Village of Crestline

SPECIFICATIONS FOR WWTP IMPROVEMENTS – PHASE I

ADDENDUM NO. 4

May 9, 2014

TILE WALL INSTALLATION
NOT TO SCALE

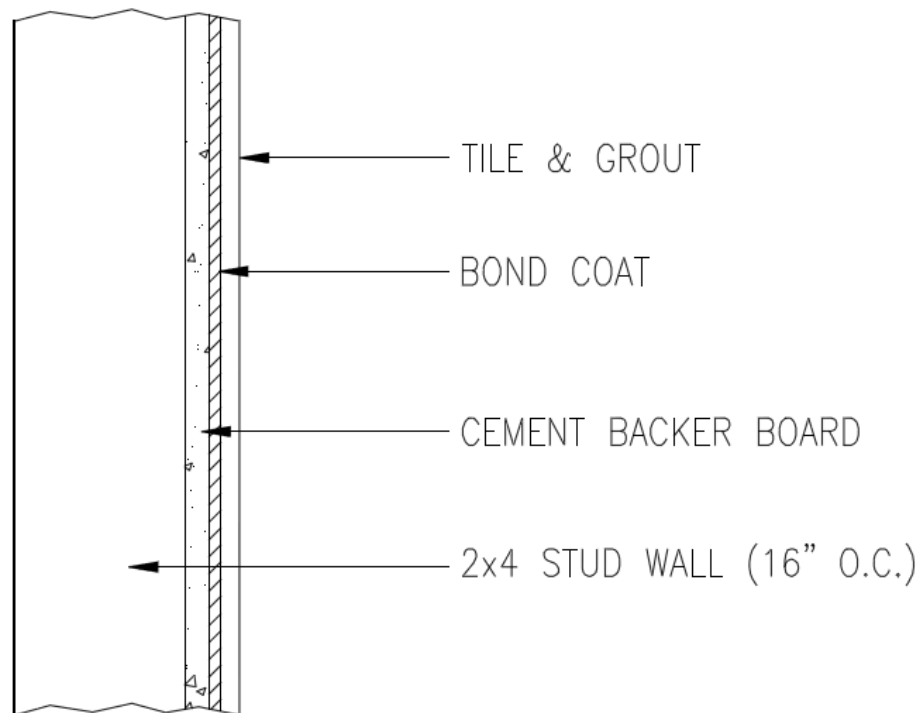
All walls not shown as being block, shall be wood framed with tile finish. (8'-8" floor to ceiling height). Tile manufactured by Daltile, Sierra type or approved equal, color to be selected by owner.

TYPICAL HANDRAILING DETAIL
NOT TO SCALE

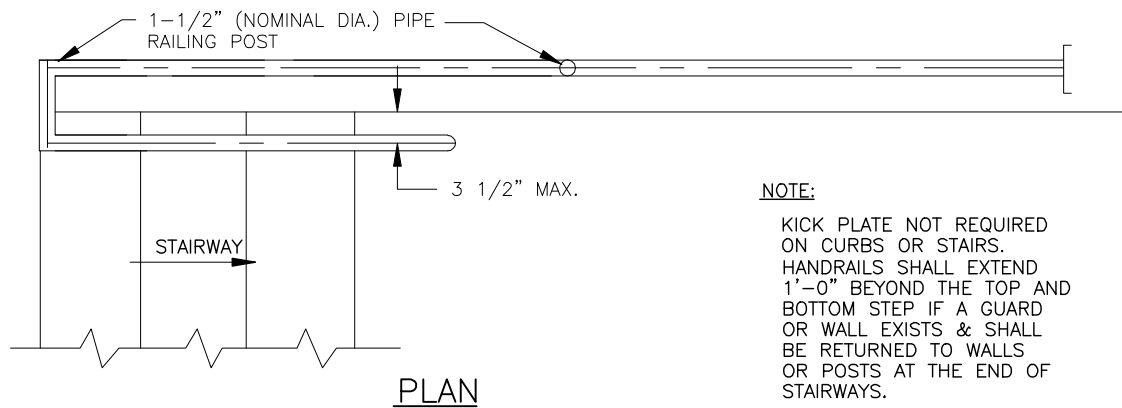
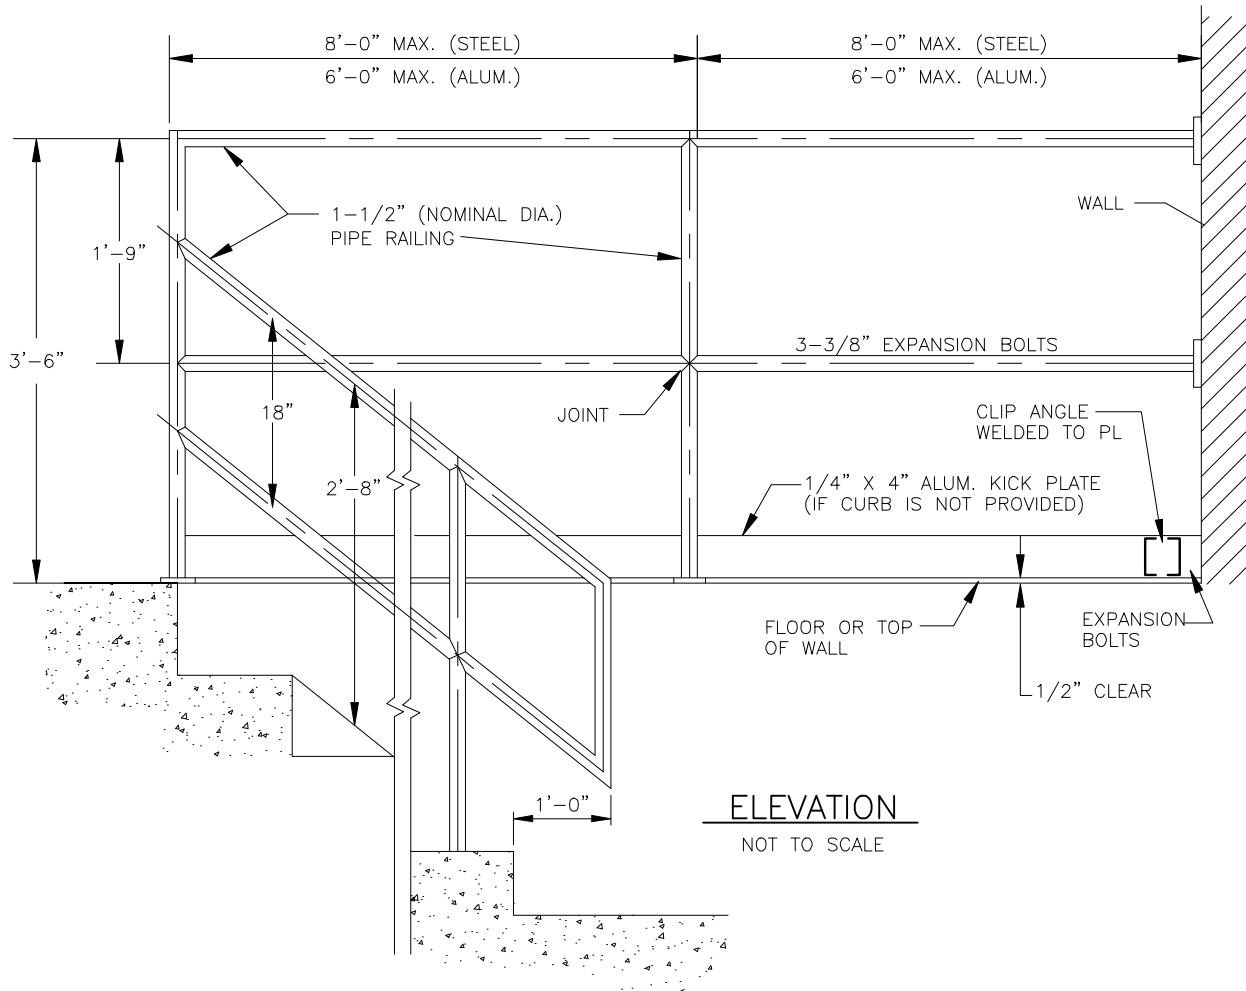
3. **Typical handrail detail provided**

This is a detail to provide a general layout of handrails and is not an exact layout for any part of the project.
